UNITED STATES PATENT AND TRADEMARK OFFICE

APPLICATION NO.	FILING DATE	FIRST NAMED INVENTOR	ATTORNEY DOCKET NO.	CONFIRMATION NO.
10/781,187	02/17/2004	Andrew P. Nguyen	6601.P041	1768

Office Action Summary

DETAILED ACTION

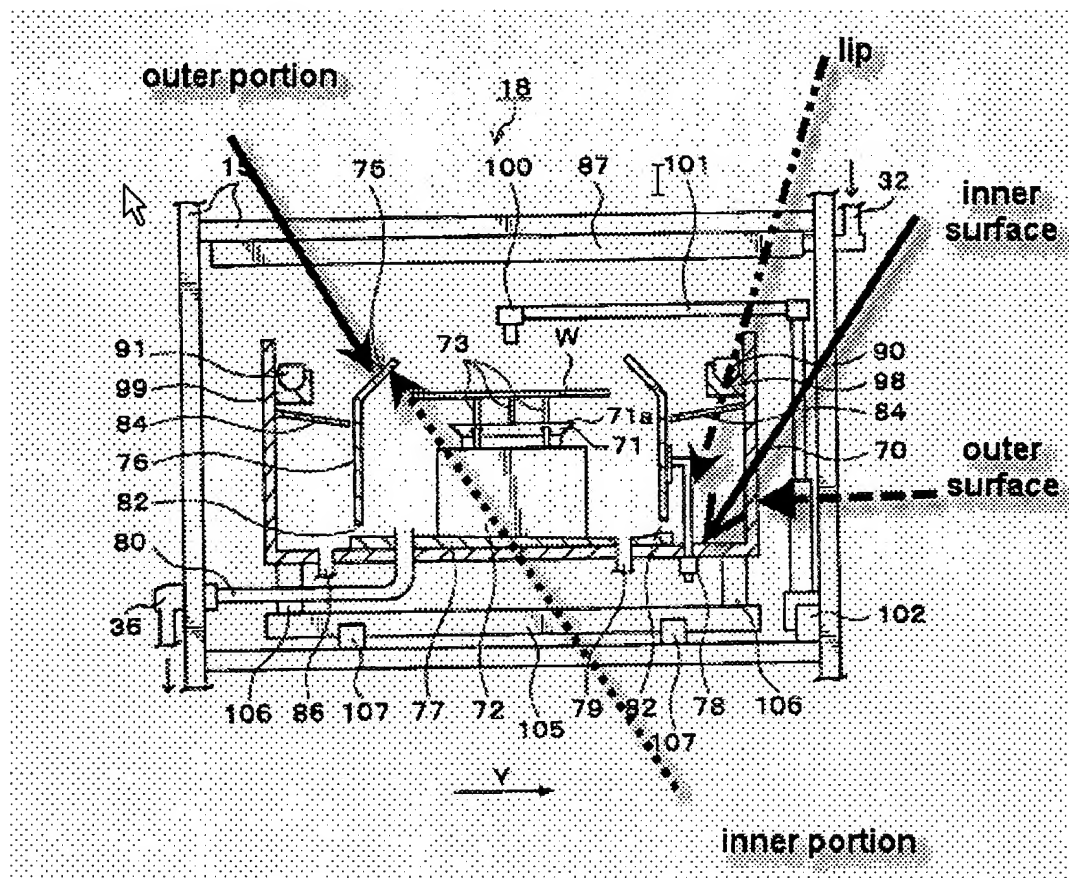
As to claim 1, Nagamine discloses (see Fig 6) a semiconductor substrate processing apparatus comprising a frame (15); a semiconductor substrate support (chuck 71) to support a semiconductor substrate (W), the semiconductor substrate having a central axis; a dispense head (90,91 and 100) connected to the frame to dispense a semiconductor processing fluid onto the semiconductor substrate; and a catch cup section attached to the frame having an inner surface and an outer surface (cup 70 having outside and inside surface, in the inside section items 75 and 84 included), at least a portion of the inner surface (see a portion of plate 84) not facing towards the central axis of the semiconductor substrate (W), wherein the catch cup further comprises a lip (75) extending from the inner surface thereof towards the central axis of the semiconductor substrate, and wherein the lip is angled such that an inner portion of the lip is angled such that an inner portion of the lip is higher than an outer portion of the lip above the plane (see drawing of Fig 6 below for the inner and outer surfaces of the cup).

As to claim 30, a line normal to and extending only away from the inner portion of the top surface of the mid-section of the catch cup (item 75) intersect the central axis of the substrate and a line normal to and extending only away from the outer portion of the top surface of the mid-section (of 75) of the catch cap does not intersect the central axis of the substrate (see Fig 6).

With respect to claims 31-32, at least a portion of the lower surface of the lip (tip 84) of the top section of the catch cup faces away from the central axis of the substrate and a line normal to and extending only away from the lower surface of the lip (tip 84) of the top section of the catch cup does not intersect the central axis of the substrate (see Fig 6).

6. Applicant's arguments filed 07/08/2005 have been fully considered but they are not persuasive. Applicants mainly argue that Nagamine does not teach a lip angled such that an inner portion of the lip is higher than an outer portion of the lip. Examiner disagrees. As shown in Fig. 6 (see below) Nagamine discloses an angled lip (75) having an inner portion of the lip is higher than an outer portion of the lip above the plane (the arrows pointing the sections of the portions, whereat the inner portion of the lip is higher than the outer portion of the lip above the plane).
